**Re: Project, Permit No. M-1980-244;
Stormwater Preliminary Adequacy Review, Amendment Application (AM-13)**

The Division of Reclamation, Mining and Safety (Division) has completed its preliminary adequacy review (PAR) of your Cresson Project 112d-3 Reclamation Permit Amendment Application (AM-13), Volume III, Appendix 3 “Stormwater Management Plan (SWMP) and Valley Leach Facility (VLF)/Overburden Storage Area (OSA) Closure Stormwater Analysis Report”. The Division sent a Preliminary Adequacy Review (PAR) Letter for the all sections of the AM-13 Application (except this stormwater section) on April 3, 2020. The **decision date for the application** has been set to **May 31, 2020**.

Figure 6 Markup

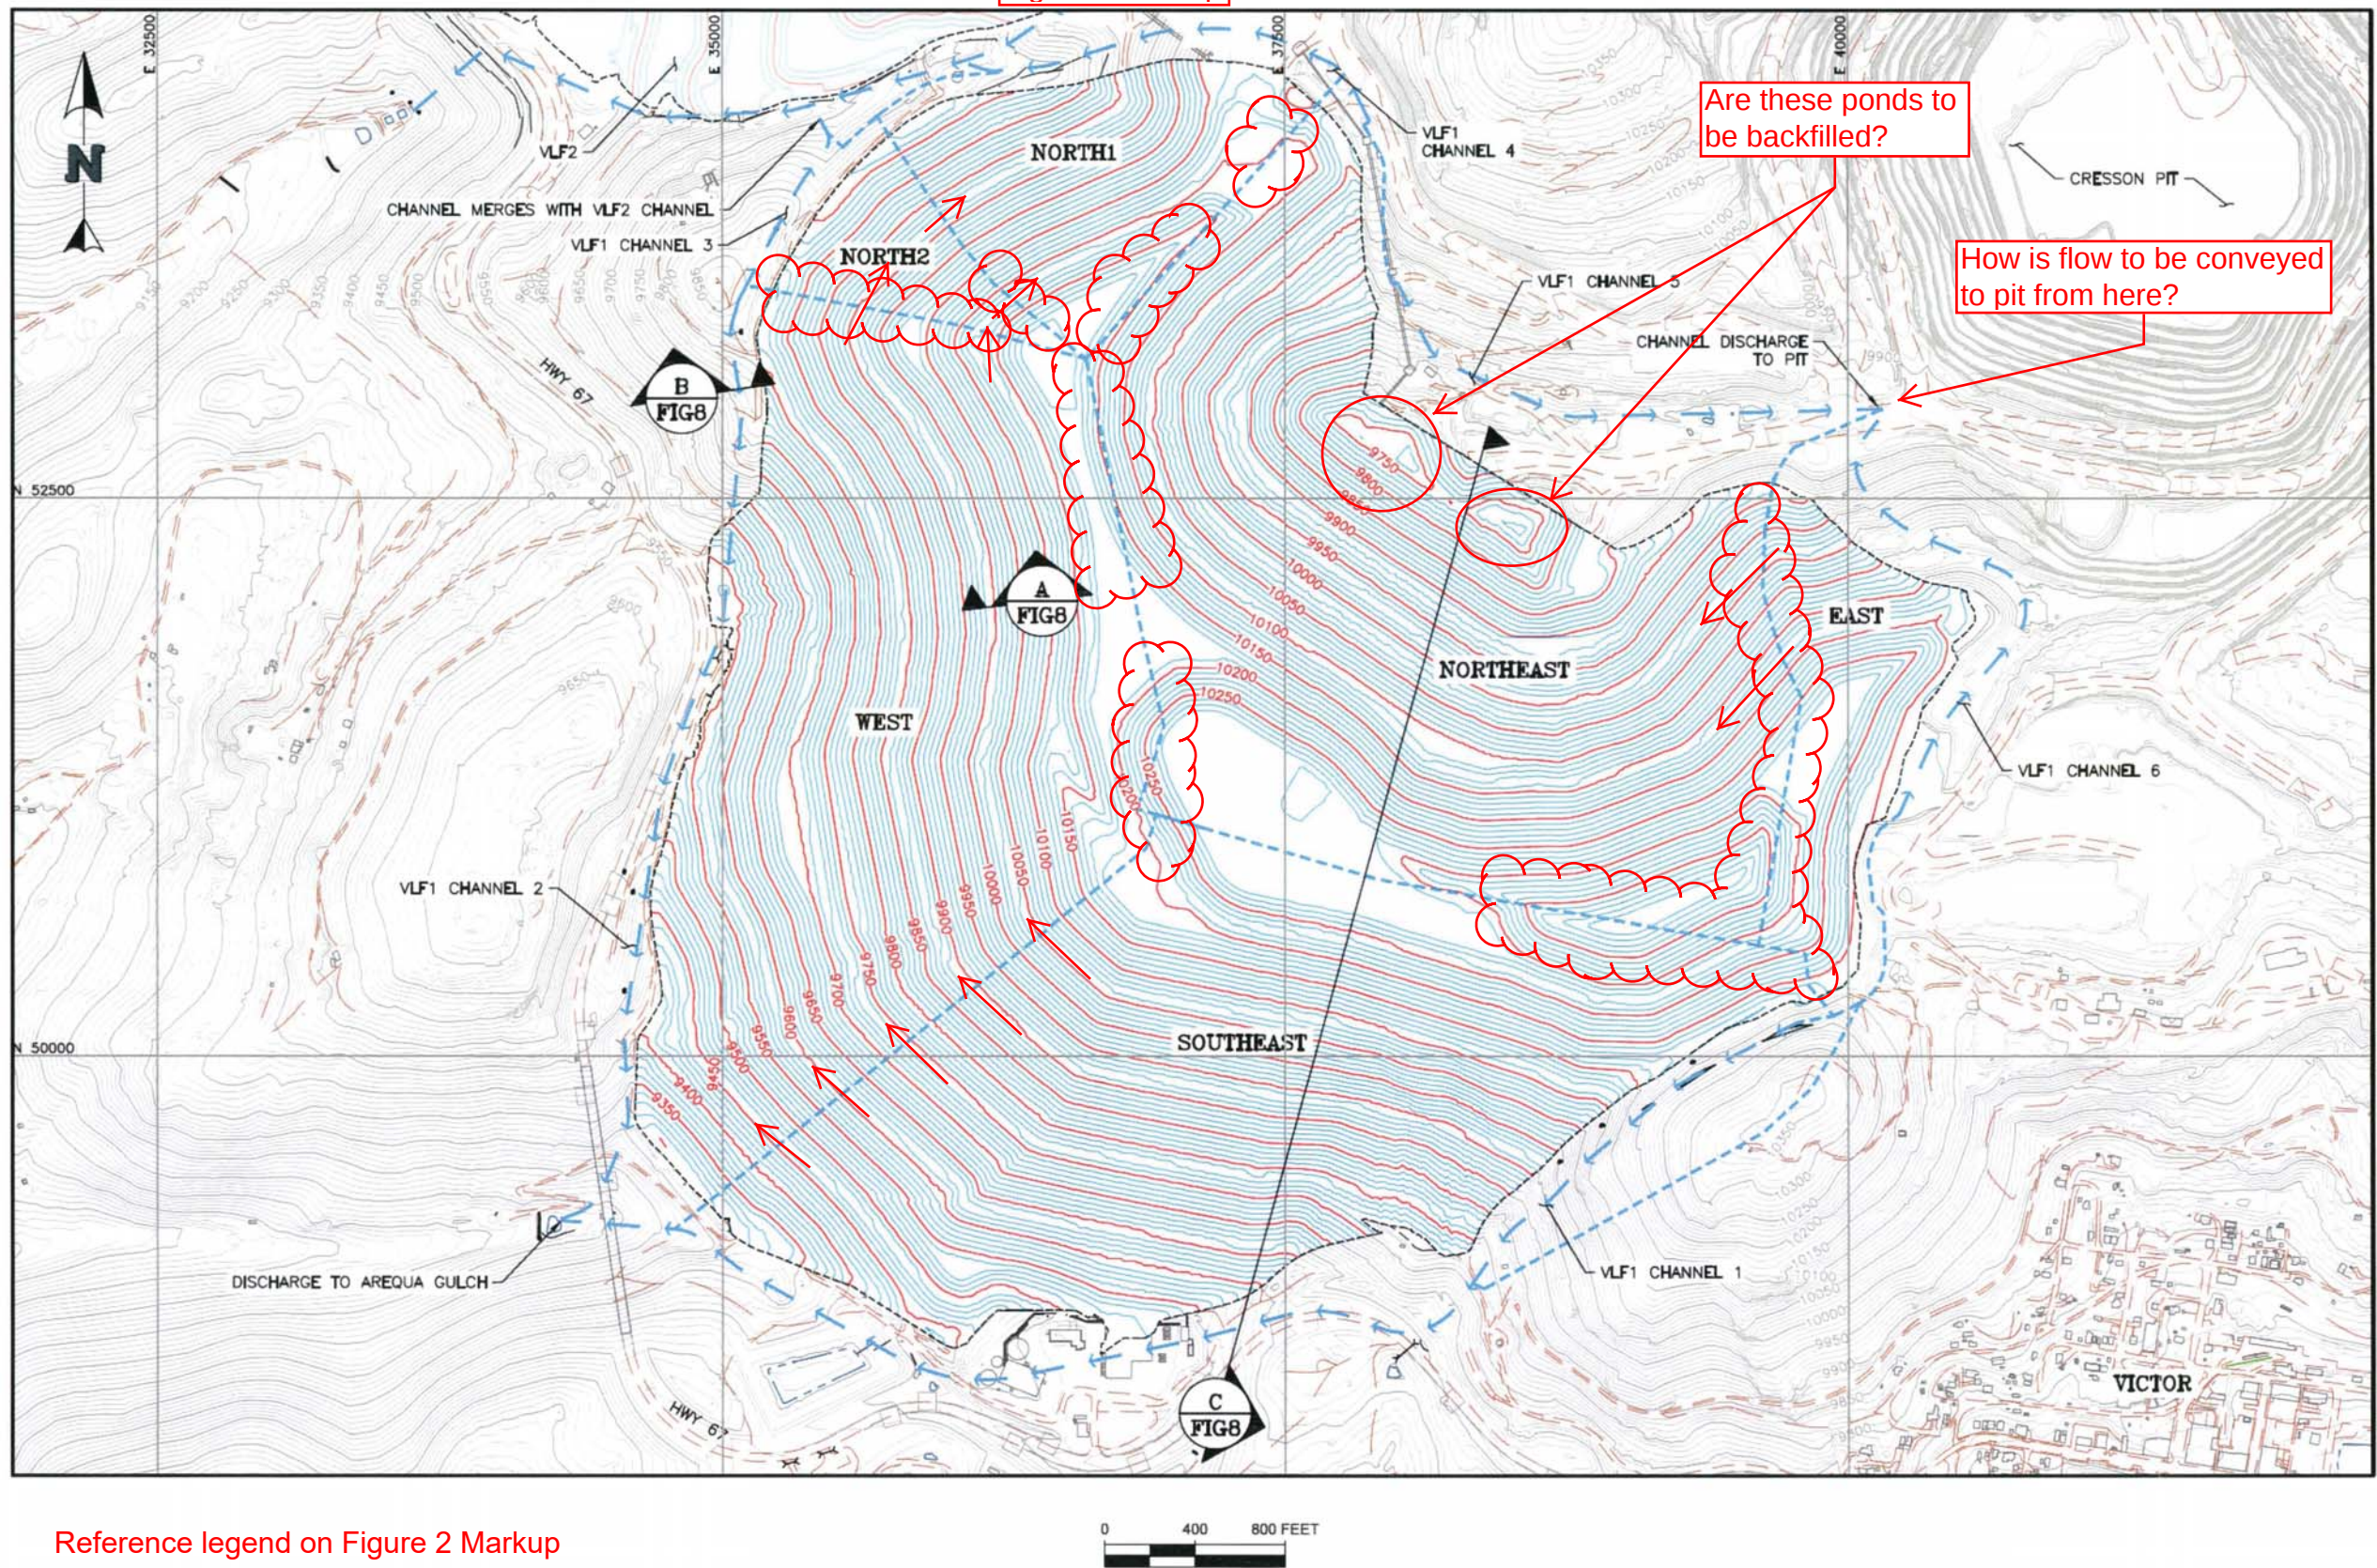
N. Figure 6. Please reference the enclosed Figure 6 Markup and address the following:

- a. Watershed delineation labels need to be added to the legend,
- b. Watershed delineations are inconsistent with the grading plan,
- c. How is runoff conveyed from the termination of the VLF1 Channels 5 and 6 to the Cresson Pit?

Figure 7 Markup

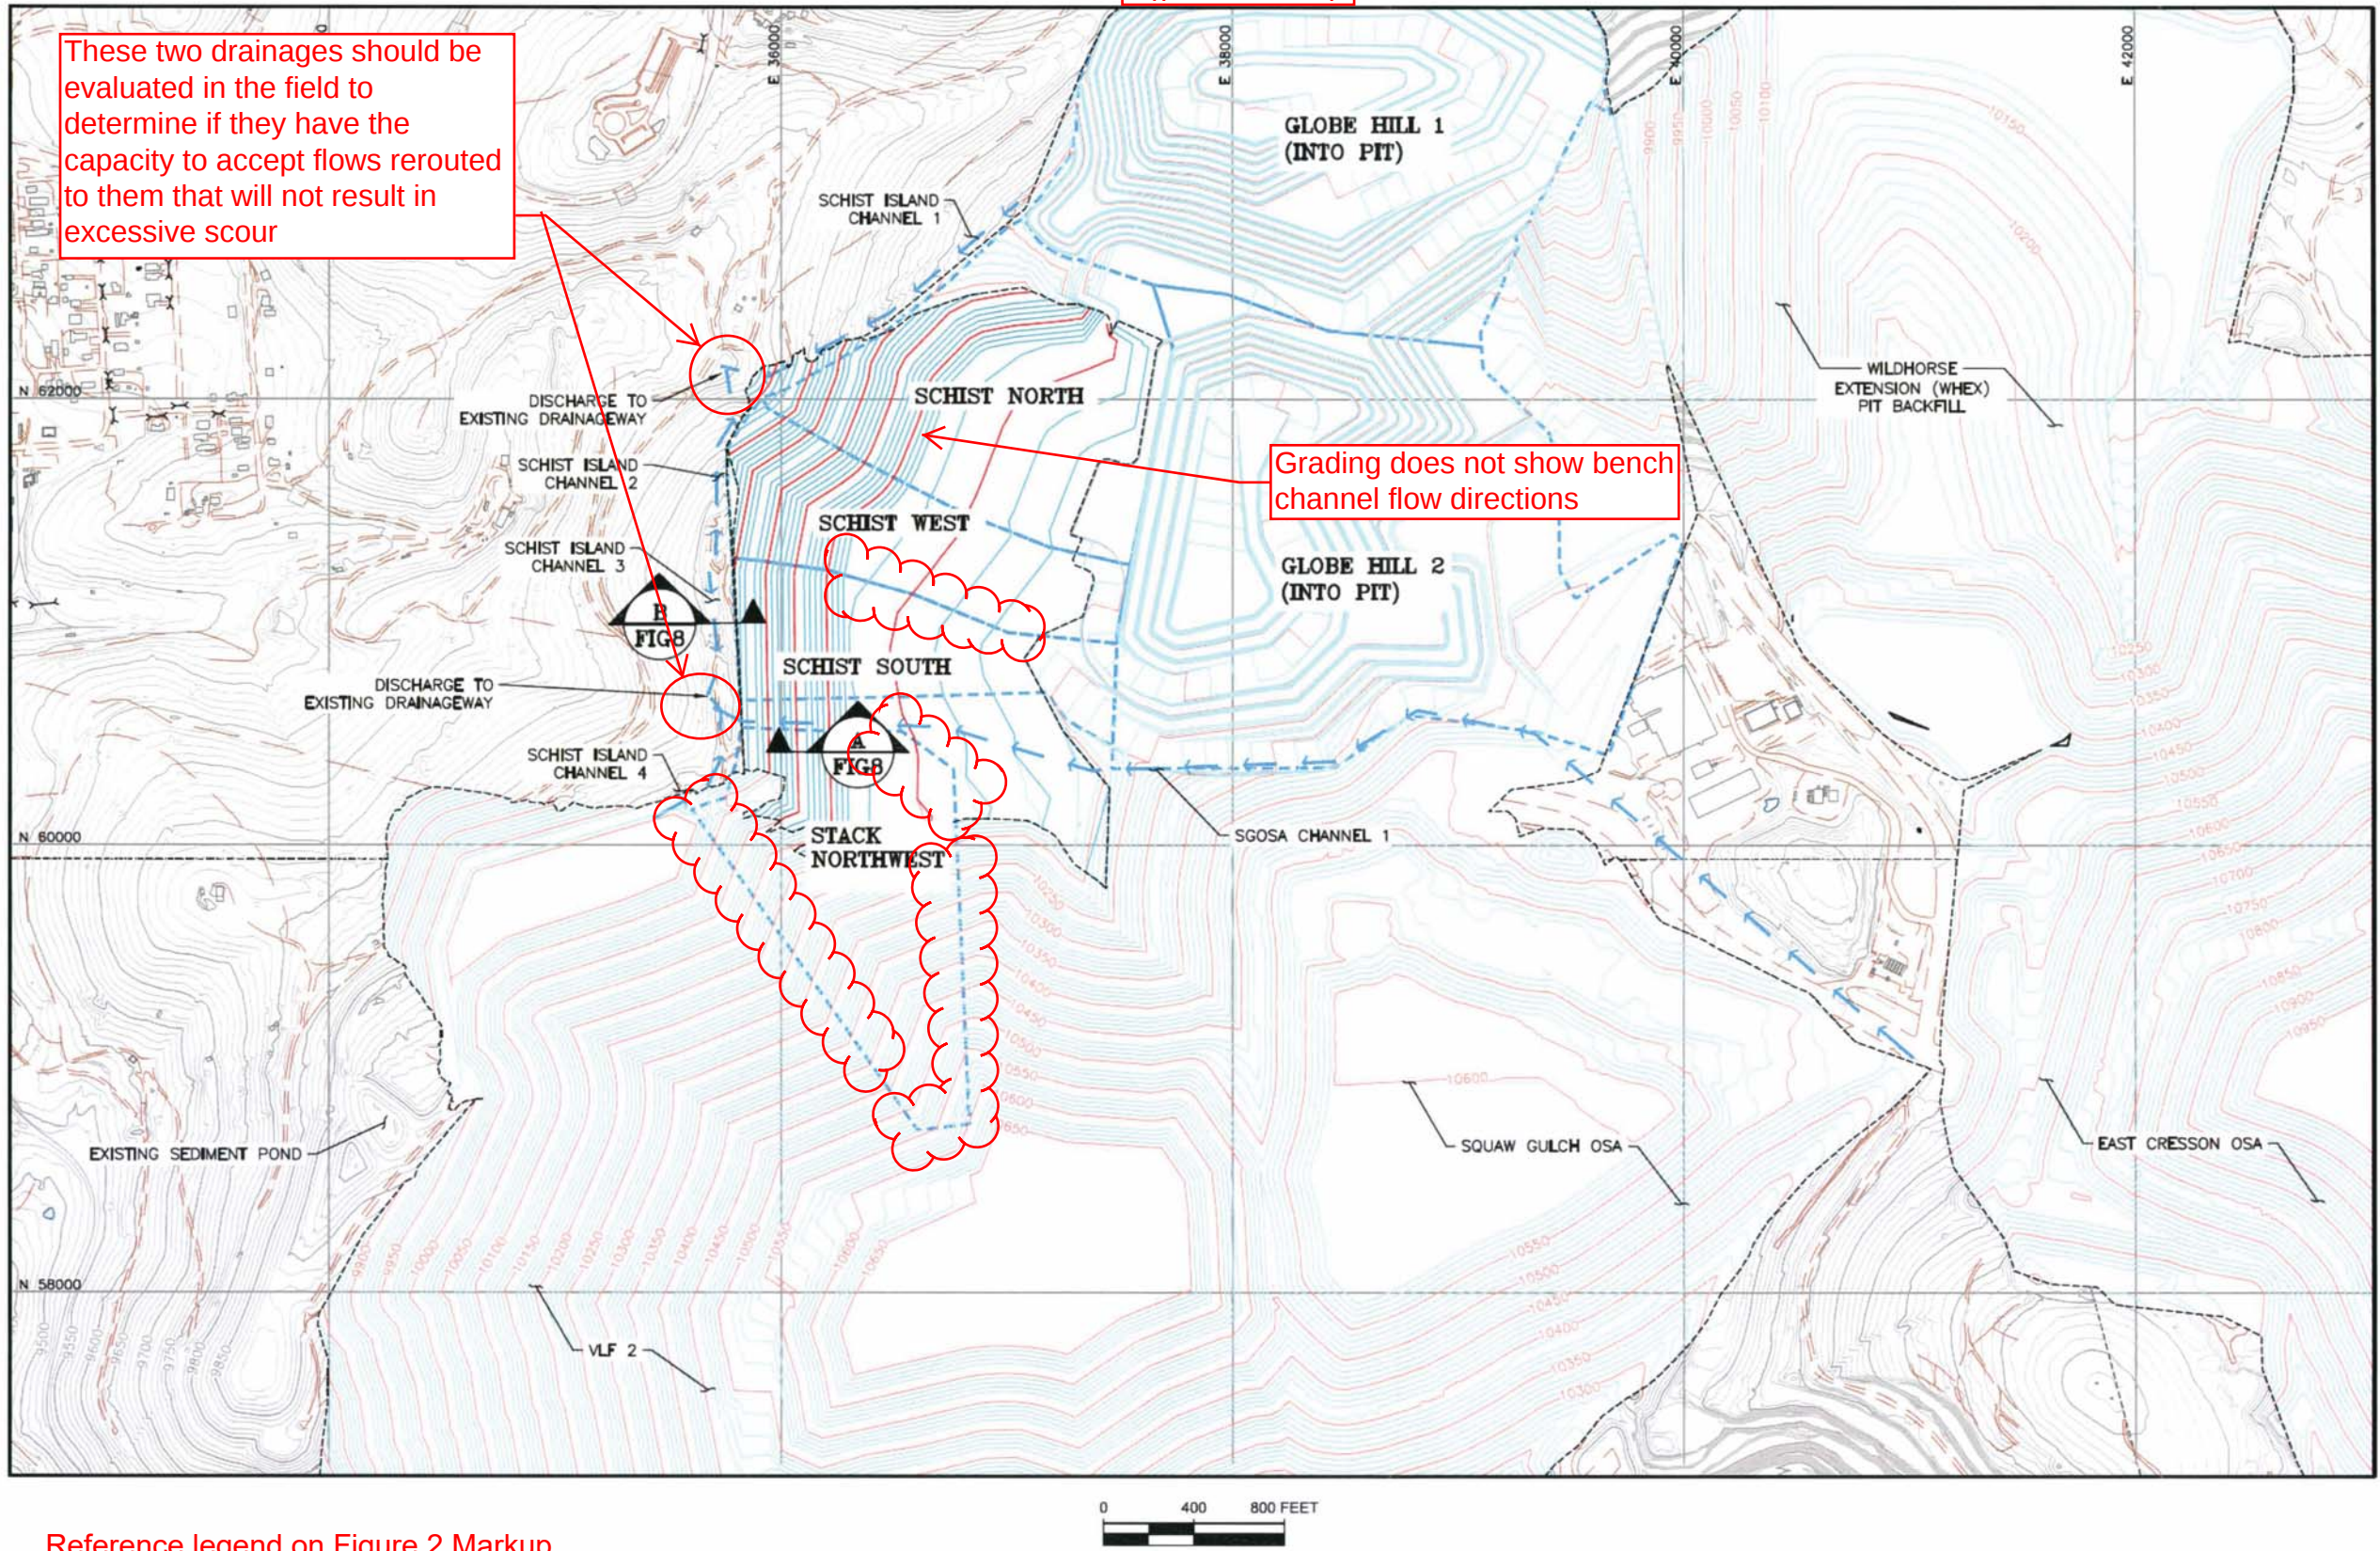
O. Figure 7. Please reference the enclosed Figure 7 Markup and address the following:

- a. Watershed delineation labels need to be added to the legend,
- b. There are two poorly defined drainages that may have considerable runoff directed to them. These should be evaluated in the field to determine if they have the capacity to accept flows rerouted to them that will not result in excessive scour.

These two drainages should be evaluated in the field to determine if they have the capacity to accept flows rerouted to them that will not result in excessive scour

Grading does not show bench channel flow directions

Figure 8 Markup

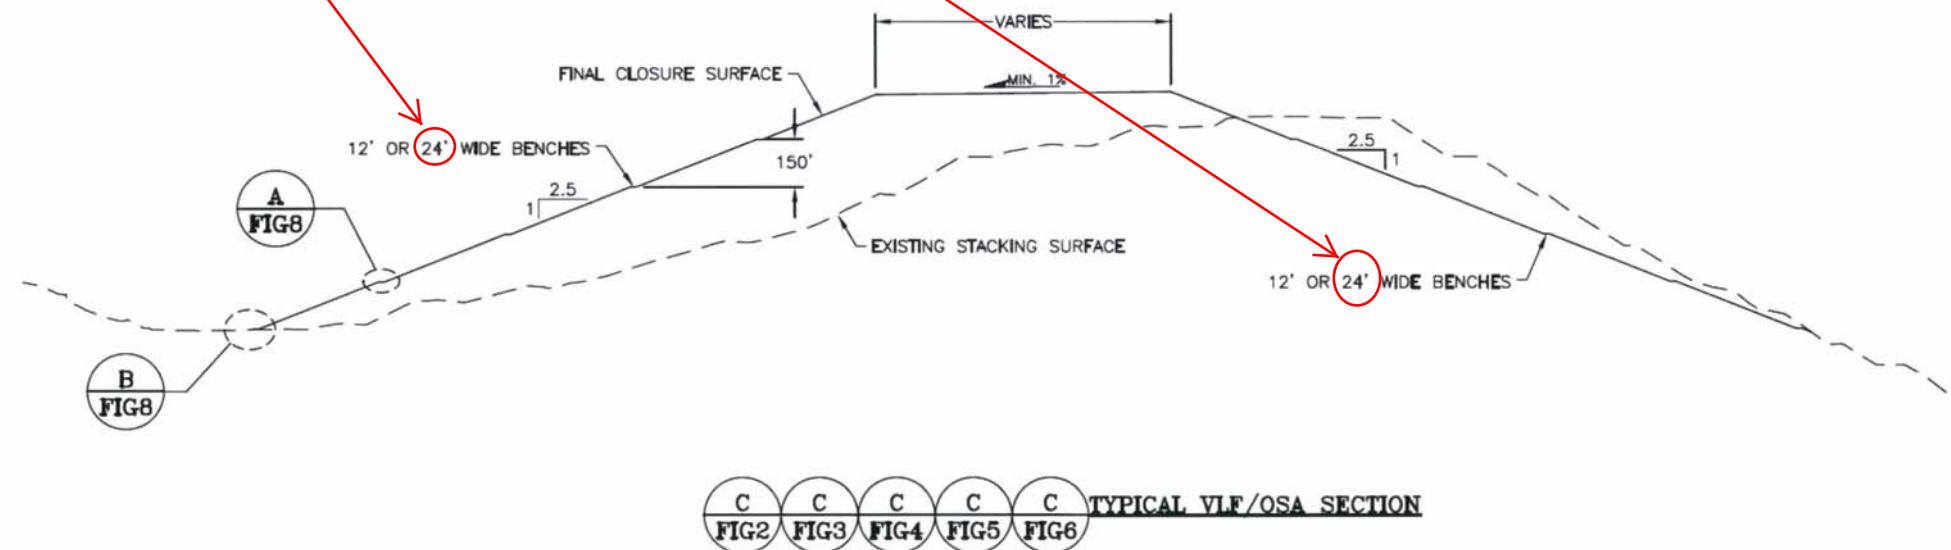
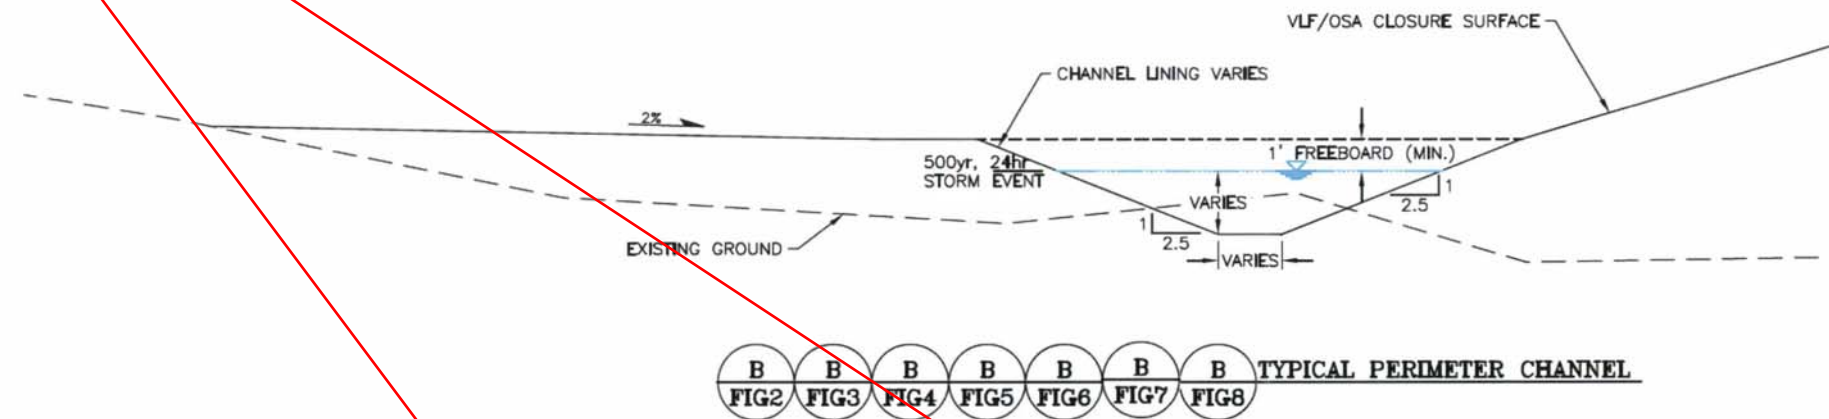
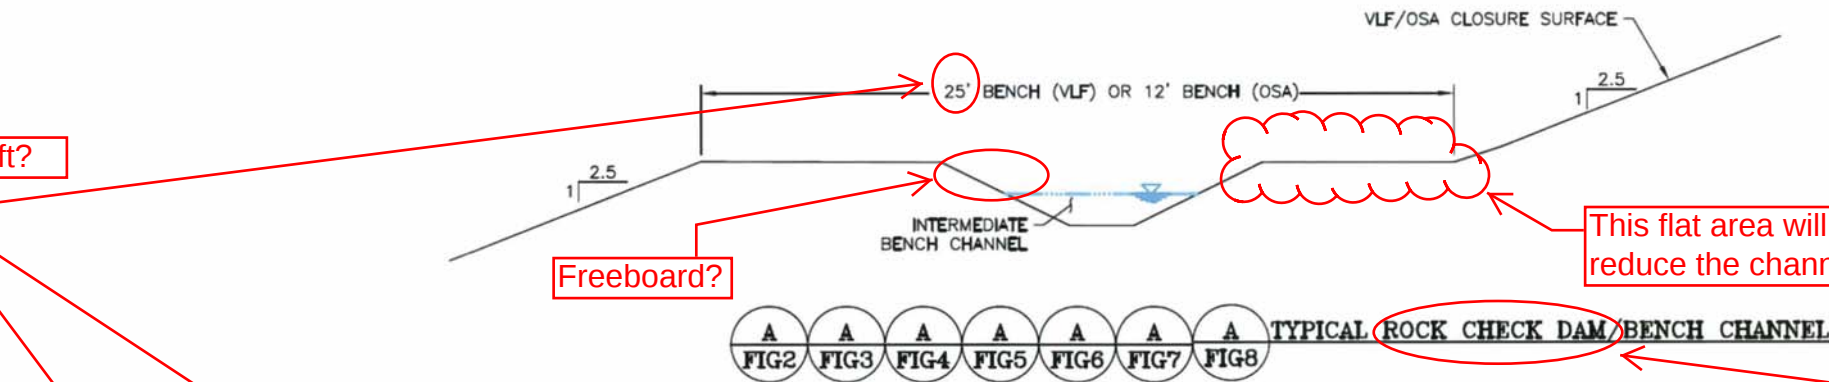
P. Figure 8. Please reference the enclosed Figure 8 Markup and address the following:

- a. There is a discrepancy between sections A and C as to whether the wider benches are 24 or 25 feet. Please correct as appropriate,
- b. This flat area between the upslope toe and the more centered bench channel will erode due to the runoff energy and generate sediment to reduce the channel capacity. Move the channel adjacent to the uphill slope to avoid this,

- c. Section A cites a “Rock Check Dam”. There are no details as to how a rock check dam would be integrated into the bench channel. This type of BMP would be expected to cause backwater conditions and likely lead to water levels exceeding the freeboard (also not specified) and resulting to overtopping, breakout erosion and channel failure. Please provide clarification and appropriate details.

Is it 24 ft or 25 ft?

Freeboard?

This flat area will erode due to the runoff energy and generate sediment to reduce the channel capacity. Move the channel adjacent to the uphill slope

How does a rock check dam fit in here?
